1 Comment (Clause 145.2.7, #45, Page 151, L15)

PClass fixed values vs. calculated values. Yair Darshan, May 2017 Rev003 Page 2 of 10

Table 145–11—Physical Layer power classifications

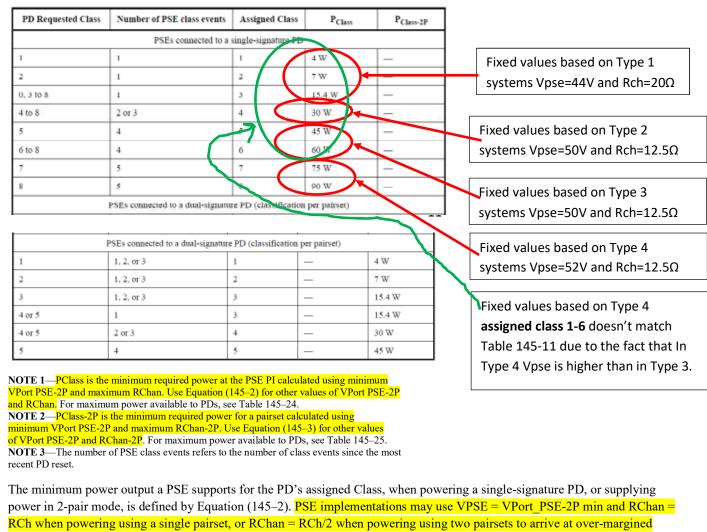
- a) If we plug the worst-case values of Vpse and Rch in Equations 145-2 and 145-3, we will not get the over margined fixed values in Table 145-11. There are significant unexplained differences in the specification.

- b) Class 1-3 value differences could be justified when Type 1 and Type PSEs was part of the 802.3bt spec. Now they are in separate clause 33.
- c) The value RCh=20 Ω for Type 1 is not realistic and should not imposed on Type 3 and 4 PSE systems and even if we impose it, the Pclass values will be lower than Table 145-11.

- d) Table 145-11 numbers for Pclass define for class 1-6 with Type 4 PSEs are much lower due to lower
 Rch and/or higher Vpse_min.
 - e) The PSE can set the true minimum PClass and PClass-2P by using Equation 145-2 and 145-3 as the intent of this spec but currently this objective is not met.

2 In some rows in the table below, the actual calculated worst case values per Equations

145-2 and 145-3 are significantly lower that the values in Table 145-11.

1. Modify Pclass and Pclass -2P in Table 145-11 per the following:

Pclass	Pclass-2P				
	1 01035 21				
4 3.92	-				
7 6.72	-				
15.4 14	-				
30	-				
4 5 45.1	-				
60	-				
75					
90	-				
-	<mark>4</mark> 3.92				
-	7 6.72				
-	15.4 14				
-	15.4 14				
-	30				
-	45

2. Modify the following text:

8 The minimum power output a PSE supports for the PD's assigned Class, when powering a single-signature PD, or
9 supplying power in 2-pair mode, is defined by Equation (145–2). PSE implementations may use VPSE = VPort_PSE10 2P min when powering using a single pairset, or RChan = RCh/2 when powering using two pairsets to arrive at over11 margined values_ as shown in Table 145–11 shows over-margined values for worst case PSE Type parameters. PClass
12 may subsequently be adjusted using Data Link Layer classification.

The minimum output power a PSE supports on a pairset for PSEs connected to a dual-signature PD is defined by
Equation (145–3). PSE implementations may use VPSE = VPort_PSE-2P min and RChan = RCh to arrive at overmargined values<u>as shown in</u> Table 145–11 <u>shows over-margined values for worst case PSE Type parameters</u>.
PClass-2P may subsequently be adjusted using Data Link Layer classification.
